In relation to your request for an extension to provide further information for DA 202139248 at Blocks 13 & 22 Section 22 Kingston.

From: [Billing, Dale](#)
To: purdons@purdon.com.au
Cc: [Varlow, Trent](#); [Richard Davies \(Richard.Davies@act.gov.au\)](mailto:Richard.Davies@act.gov.au)
Subject: DA202139248 Blocks 13 & 22 Section 22 Kingston – Further information request
Date: 17 February 2022 21:18:00
Attachments: [DA202139248 Blocks 13.docx](#)

RESPONSE TO FURTHER INFORMATION REQUEST ON DA 202139248 (B13 & 22 S22 KINGSTON)

Description - PROPOSAL FOR A NEW COMMERCIAL DEVELOPMENT - Demolition of the existing buildings, pavements and structures and construction of a new four-storey commercial building with two level basement carparking, 5 surface carparking spaces, landscaping, removal of one verge crossing from Giles Street and modified vehicle access to the Laneway to the south of Block 22 and associated works.

DRAWING TITLE		CAR PARK SWEEP PATH			
SCALE:	1:100 @A1	DRAWN:	RG	PROJECT No	2102
DATE:	24.03.2022	APPROVED:	AC	DRAWING No	SK-0003
				REVISION	1

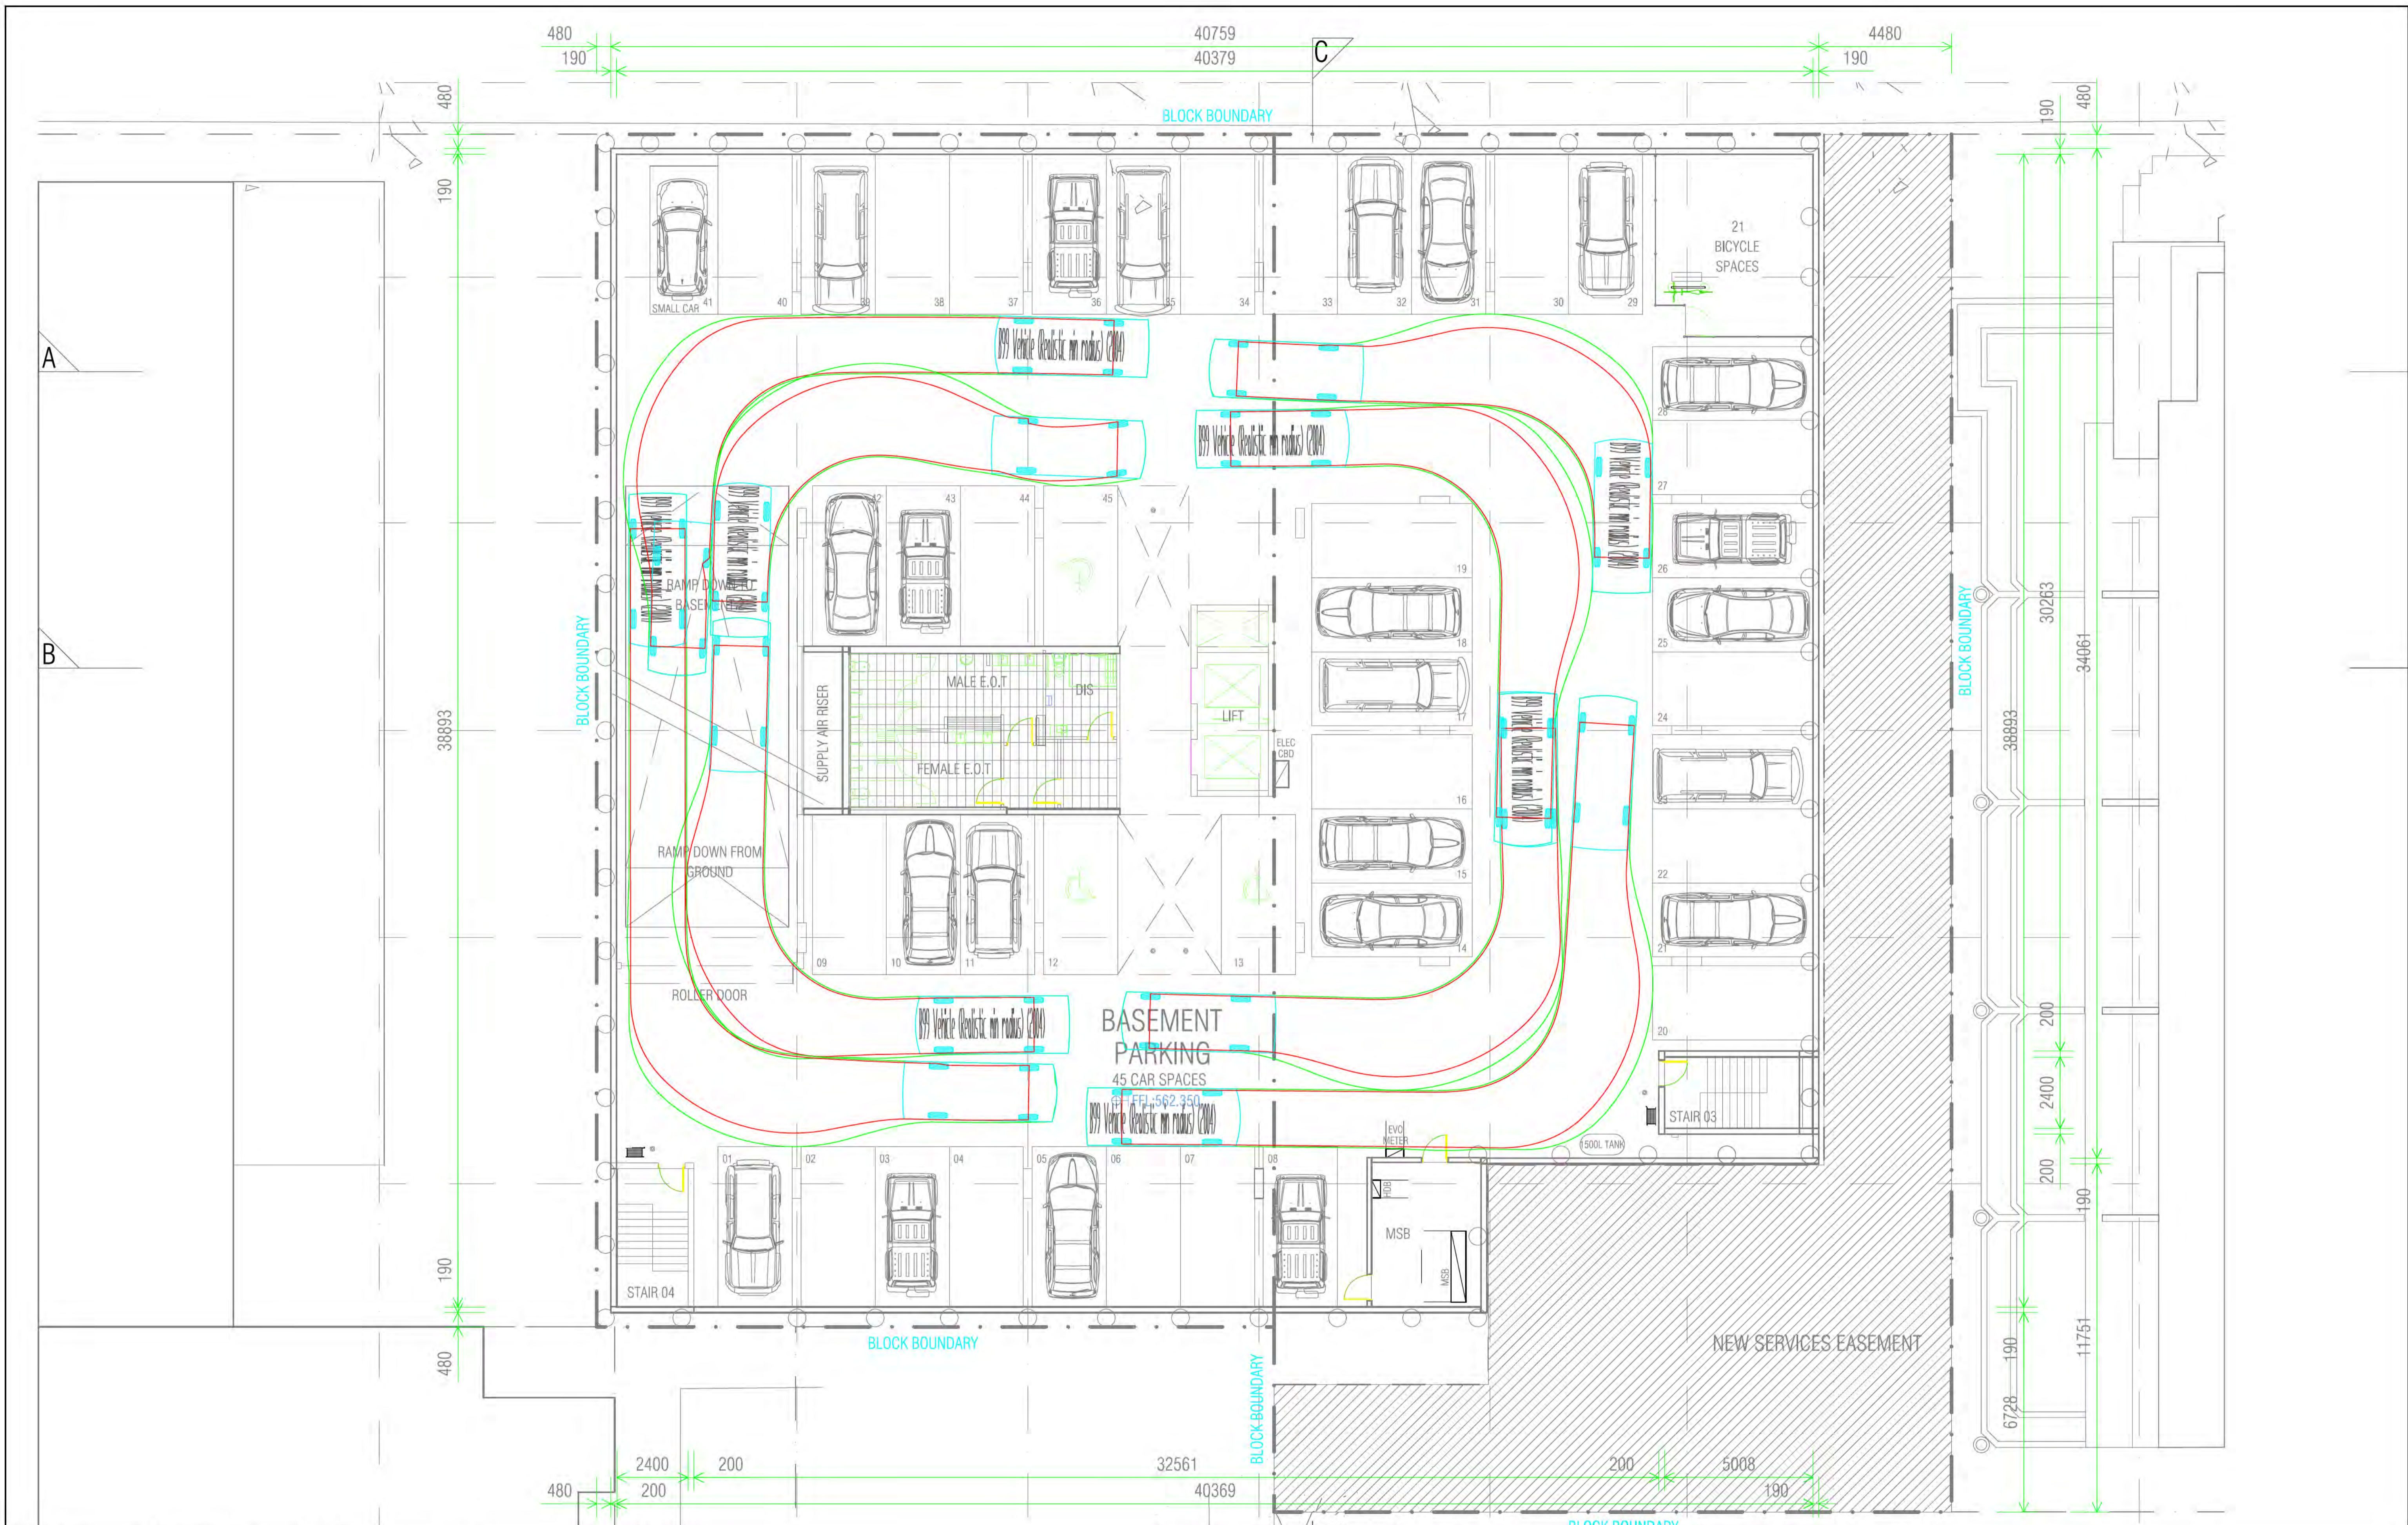
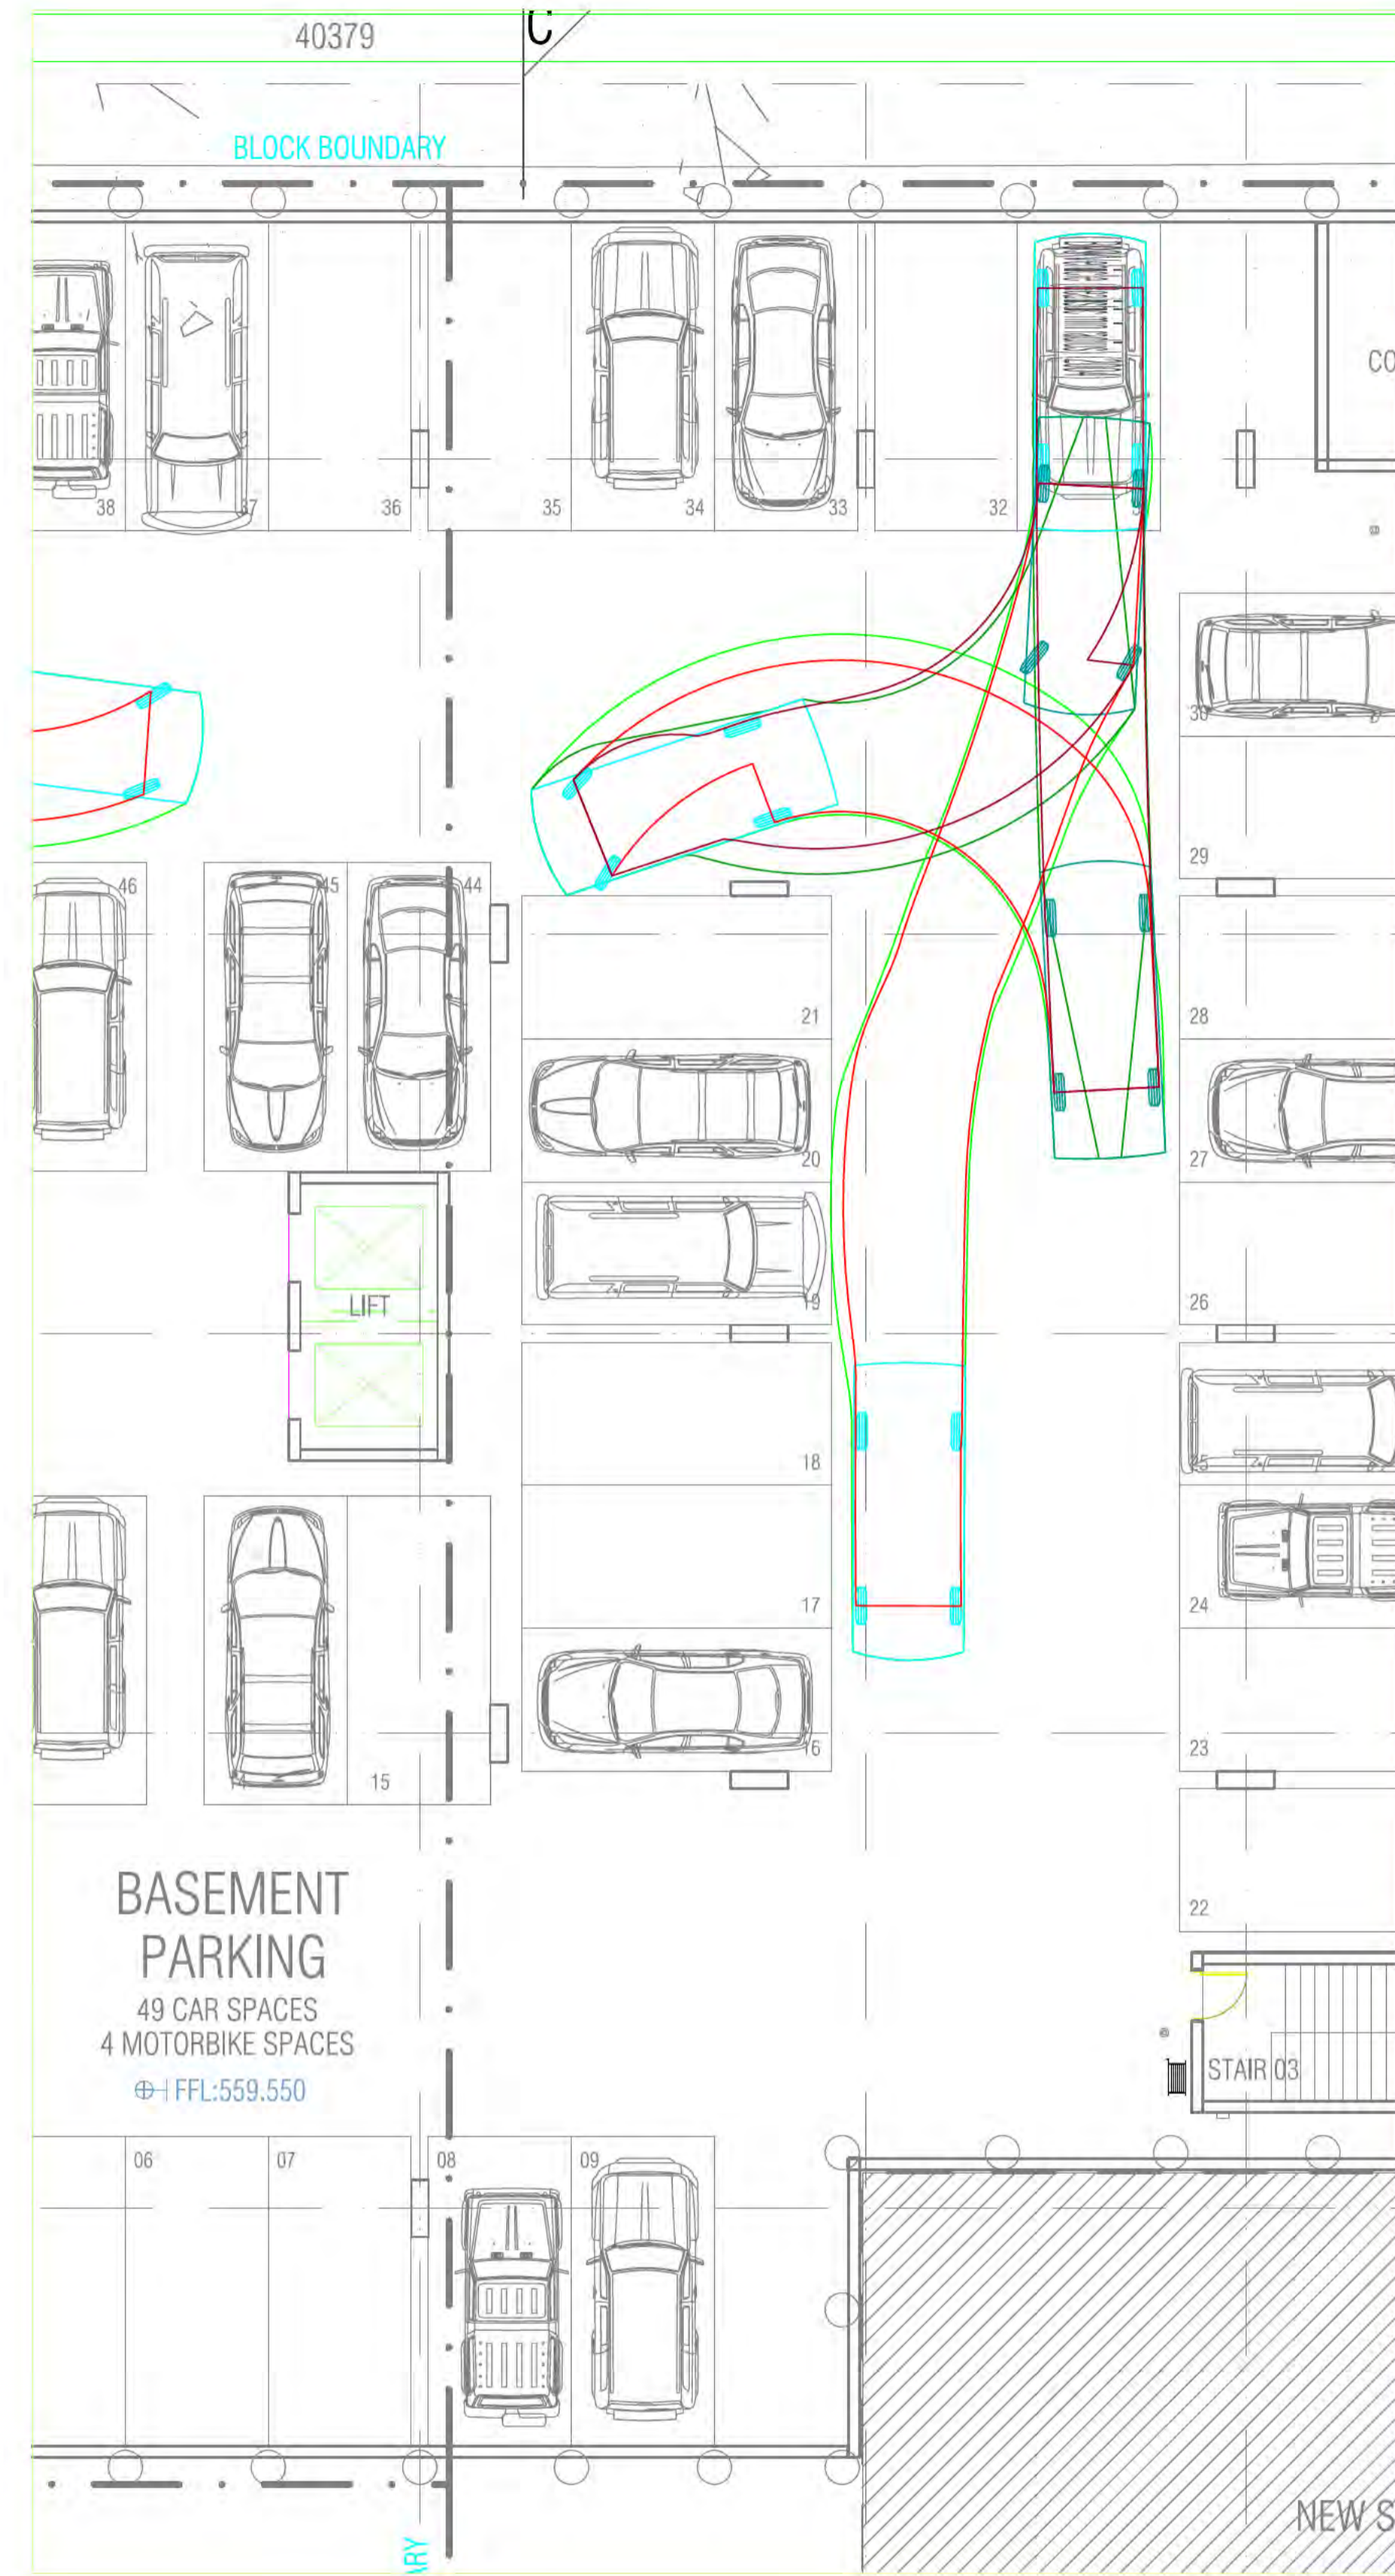
<p>Parking and Vehicular Access General Code</p> <p>Turning templates should be provide for tight turning movements into and out of parking spaces within the basement to demonstrate compliance with turning requirements.</p>	<p>Please refer to additional turning template supplied with this submission.</p>
